Product Change Notification

E4T, S4T PCB Update

PCN-6466

Figure 1, E4T PCB comparison showing existing design (left) vs. new board design (right).

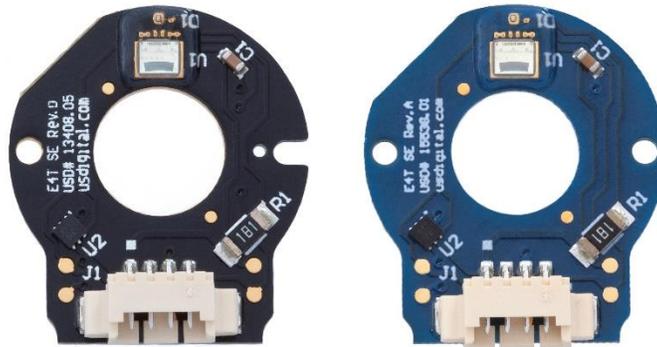
This notice is to inform our customers of a PCB design change that is being implemented for all of the E4T and S4T product lines.

As part of our continuous improvement objective, the new PCBs will improve overall product performance and enhance robustness of these product lines. The new PCBs can be identified by their blue color (instead of black) and have two mounting holes that mate with the base plate instead of one hole and one slot. This change has no impact on form, fit or function of the either the E4T or S4T.
